**SUBJECT: Carrier Subdivision
PSUB2016-00026
Public Works Approval of Variation Request**

PRELIMINARY STORM DRAINAGE PLAN
 CARRIER
 PRELIMINARY PLAT PLANS
 1240700095
 CITY OF SAMMAMISH WASHINGTON

RE: Roadway Variance Request for Carrier
PSUB 2016-00026
Blueline Job No. 15-111

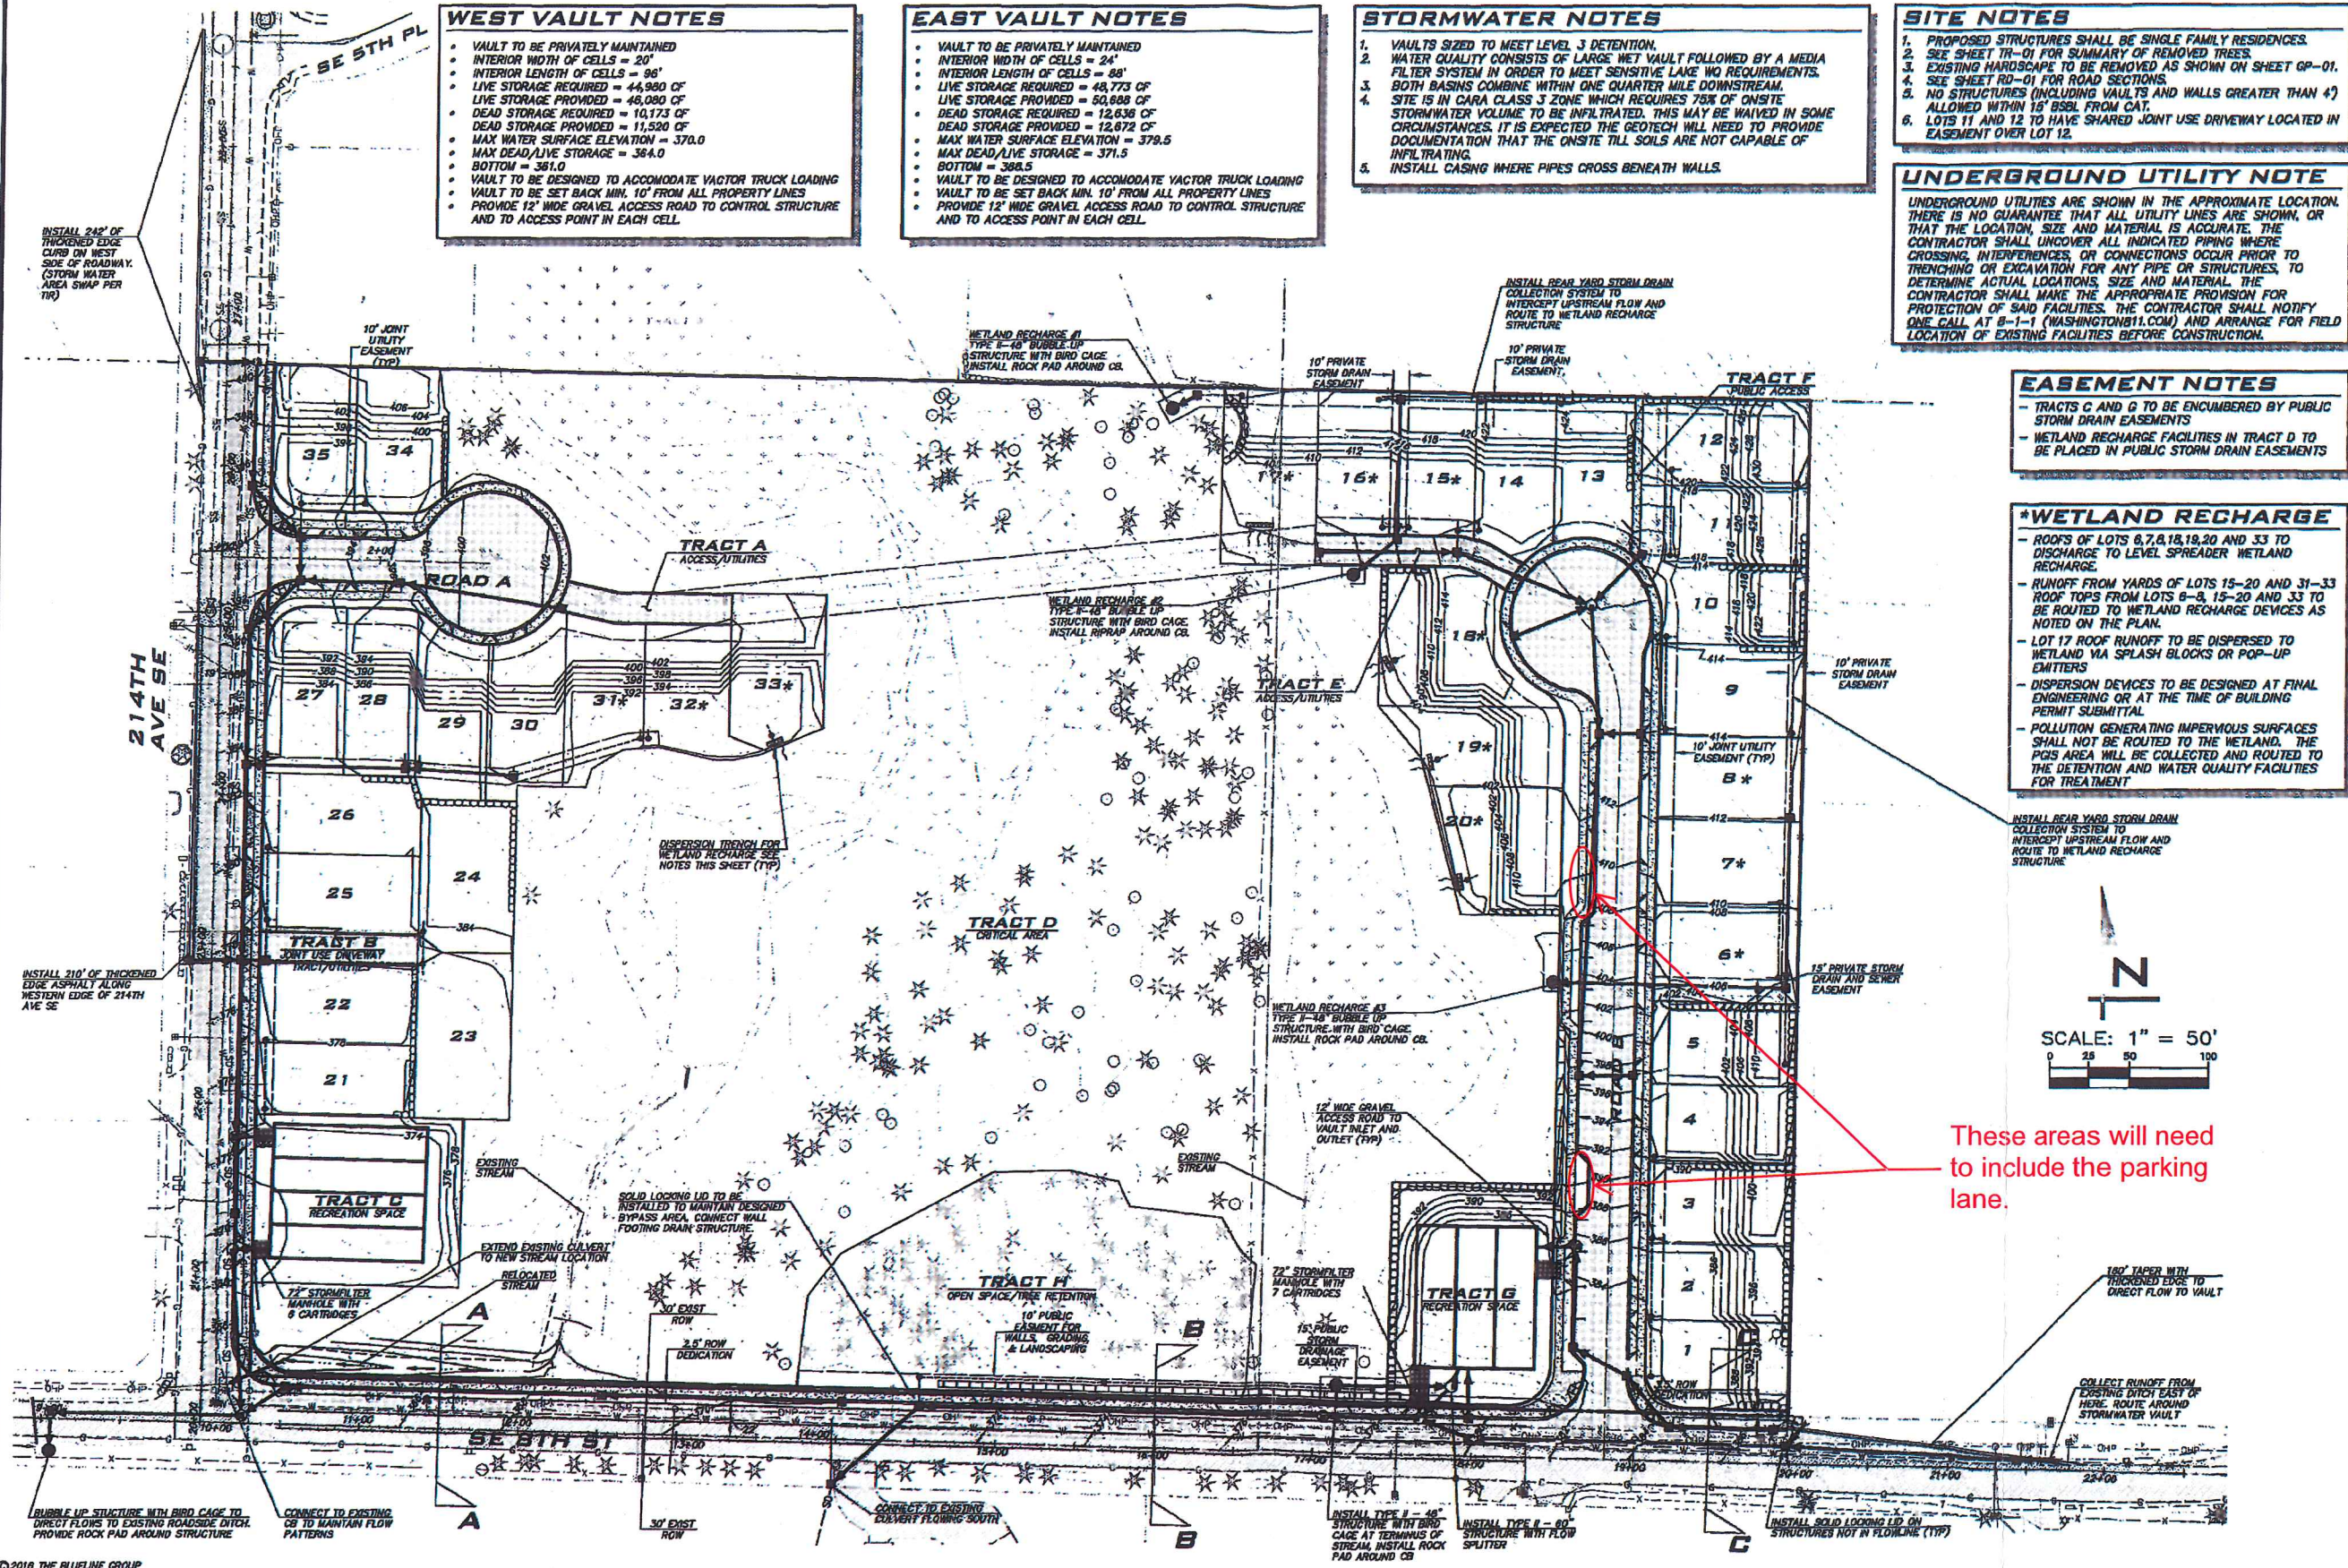
The City is acceptable to this proposal with a slight modification along Road B to provide additional parking along the west side up to the driveway to Lot 20.

These areas will need to include the parking lane.

**ROADWAY SECTION
COLLECTOR ARTERIAL**

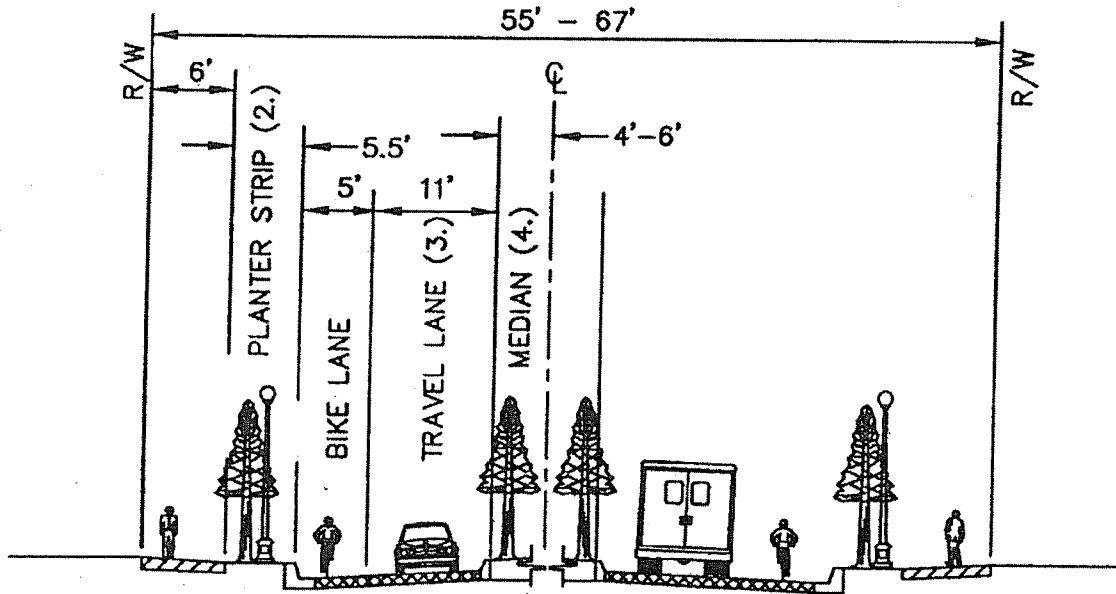
SE 8th Street is a collector arterial per PWS.51.110. In accordance with City of Sammamish Interim Public Works Standards and consistent with Figure 01-03 and Table 1 the road shall be improved to have half street improvements which include one half of an 8' to 12' median, an 11' travel lane, 5' bike lane, vertical curb and gutter with a planter strip and 6' sidewalk. Assuming a 12' planter this would put the face of curb 22' from the center of right of way. Per notes on Figure 01-03 the width of the median may be reduced and the planter strip may be eliminated or reduced subject to City Engineer's approval.

The city has requested that the face of curb be placed 24.5' from the center of existing right of way which pushes proposed improvements slightly north of right of way center. By pushing the center of improvements north, it provides additional space on the south side of the right of way between the edge of pavement and the existing trees which will help accommodate future half street improvements to the south by others. To minimize impacts to the critical areas on the north side of the right of way, the planter strip will be eliminated and the 6' sidewalk placed immediately at the back of curb which is adjacent to a proposed 5' bike which provides separation from pedestrians and the traveled way. A 2.5' ROW dedication will be granted to allow 1.5' between back of walk and new ROW limit in which to place utility poles as needed. The applicant formally requests this modified road section be approved.

Public Works will allow the following variation on the frontage along SE 8th Street between the 214th Avenue SE intersection and the intersection with the road designated as Road B in the preliminary plat plan:

- 24.5-foot pavement width from centerline of right-of-way
- Elimination of landscape strip
- 2.5-foot right-of-way dedication inclusive of a 1.5-foot added width north of sidewalk for street lights and utility poles

The design cross section shown for SE 8th Street includes all the elements that were identified by the City's Public Works and Parks departments in coordination with input from public and City Council. At the East end of the project the cross section will match a half street design of a collector arterial with a 3-foot wide right-of-way dedication along the project frontage. Between the proposed Road B and the intersection with 214th Avenue SE is a sensitive area corridor along both sides of SE 8th Street. The roadway through this sensitive area corridor will be ultimately inclusive of two 11-foot wide lanes, two 5-foot wide bicycle lanes and two 6-foot wide sidewalks. This project will construct the portion of the ultimate design located between the center of the right-of-way and the new right-of-way line. The project will be required to dedicate a 2.5-foot width of right-of-way along the frontage through the sensitive area corridor. After the improvements are constructed for this project, there will be more than sufficient pavement width for safe vehicular, bicycle, and pedestrian movement through this corridor.

ROADWAY SECTION
LOCAL ROAD

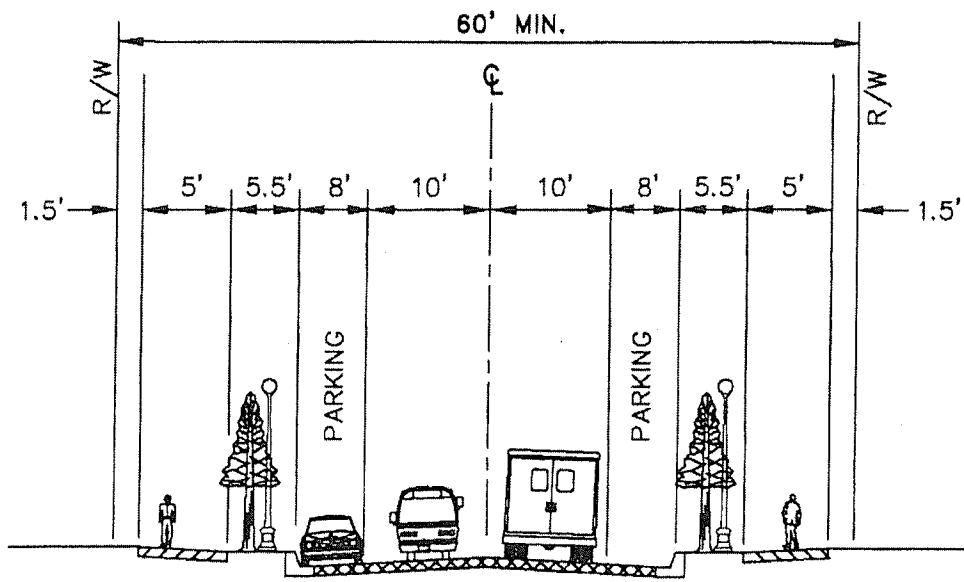
The onsite road meets the definition of local minor access road per PWS.15.050. B.4.b. In accordance with City of Sammamish Interim Public Works Standards and consistent with Figure 01-05 as modified by City Ordinance 2005-191 the onsite road shall meet a local road standard of 60' of ROW dedication, 36' of pavement width curb to curb, 5' planter strip and 5' sidewalk width on both sides. The 36' of pavement is intended to accommodate two 10' travel lanes and an 8' parking lane on each side of the roadway. Per notes on Figure 01-05 the on street parking may be reduced with City Engineer's approval for cul-de-sac streets.

The applicant formally requests that the internal plat road standards be modified such that parking is reduced to one side only for Road A which reduces the pavement width from 36' to 28' as shown on the attached plan. The requested modification results in a roadway with 28' of pavement measured curb to curb, vertical curb and gutter, 5' of planter strip and 5' of sidewalk both sides and a 60' ROW.

For Road B, only portions of the roadway are proposed to be reduced to 28'. In addition to the reduction in pavement width, the planter strip will be situated behind the sidewalk in select areas to allow grading between the back of walk and adjacent critical areas. Refer to the attached plan sheets for locations.

Public Works will allow the following variation along the internal plat road identified as Road A and a portion (as depicted on attached Exhibit) of the internal plat road identified as Road B:

- 28-foot pavement width
- No Parking signs on one side
- 5.5-foot from behind back of sidewalk to edge of ROW on each side

The design cross section shown for the inner plat local roads shows a reduced pavement width from the standard 36-foot width to a 28-foot width along Road A and sections of Road B. Along both roads the proposed design provides mostly similar safety features as required by the standard Public Works roadway design. The design includes a 10-foot wide vehicular travel lane in each direction, two 5-foot wide pedestrian walkways separated from the road by a 5-foot wide landscape strip, and an 8-foot wide parking lane on at least one side of the road. Along a portion of Road B, the landscaping strip is proposed to be eliminated, which would result in a stretch of sidewalk that is adjacent to the road. Elimination of parking on one side of the road for all of Road A and parts of Road B will continue to provide the same level of safety for these roadways relative to the standard design. The elimination of a landscape strip near a highly sensitive area will provide sufficient pedestrian safety while protecting valuable resources.

The variation along Road A and a portion of Road B will have reduced parking on one side of the road. The function of the roadway would be maintained with the proposed variation, with respect to pedestrian and vehicle use. The narrower 28-foot wide road would help discourage higher speeds for vehicles. Furthermore, as no right-of-way reduction is proposed, the variation will not yield a higher density opportunity for the applicant.
